Resource Management Act 1991

Decision and Planning Report

APPLICATION NUMBER(S)	RC246059
APPLICANT	Ra Tuatahi No. 1 Limited
BRIEF DESCRIPTION OF THE APPLICATION	This is a land use consent for the construction and operation of a 10ha solar array (solar farm).
ADDRESS	80 Struie Road, Hororata
LEGAL DESCRIPTION	Lot 6 DP 66179
TITLE REFERENCE	CB38D/1003
AREA	10.214 ha
ZONING / OVERLAYS	Operative Selwyn District Plan (2016), Rural Volume
	Outer Plains Zone
	Partially Operative Selwyn District Plan (Appeals Version)
	General Rural Zone
	Plains Flood Management Overlay
	Liquefaction Damage Unlikely Overlay
	Rural Density (SCA-RD3)
OVERALL ACTIVITY STATUS	Discretionary

Figure 1: Affected Parties

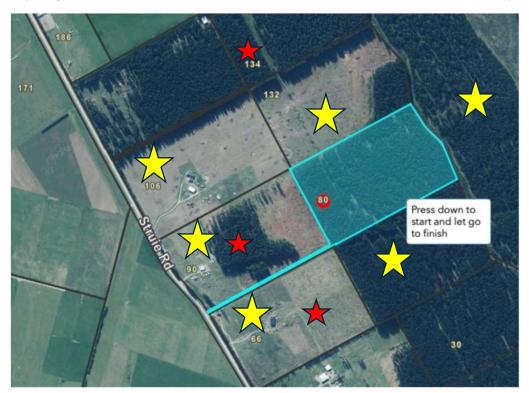
- 1.7 Using the Visual Effects Ratings and Categorisation table, and acknowledging that an 'effect' as defined in Part 3 of the Act includes a temporary effect, I find that there will be a minor adverse visual effect (at least until the planting reaches maturity) on the immediately adjoining properties highlighted with a yellow star in figure 1 below (noting the written approval has been provided from the parties identified with a red star):

- 1.8 For clarity, I record that an adverse effect is not limited to a fixed audience. Rather, a property owner has the right to enjoy their property, regardless of whether they live there, who is using it, or how it is currently being used.
- 1.9 Similarly, I am not satisfied that adverse effects in respect to rural character will be less than minor on adjoining properties. I agree with Mr. Gregg that the proposal is of a relatively modest scale and height on a rear site which limits wider inward views such that the change in rural character would not necessarily be apparent beyond those immediate neighbours. However, given the proposal seeks to introduce structures and infrastructure uncommon (and not within the range of permitted activities) in the rural environment, the proposal

will alter the site's character from open and rural (acknowledging that it was previous forestry) to one associated with energy infrastructure. While mitigation planting may reduce *visual effects* over time, the fundamental change in land use and the presence of non-rural structures mean that adverse effects on rural character for adjoining parties will be at least minor.

- 1.12 For the reasons detailed herein, I find that adverse effects in respect to visual amenity and rural character will be at least minor. Accordingly, resource consent application RC246059 to construct and operate a 10 hectare solar array (solar farm), at 80 Struie Road, Hororata, is to be processed on a **limited notified** basis to the parties identified with a yellow star in Figure 1 above³, in accordance with sections 95A-E of the Resource Management Act 1991.
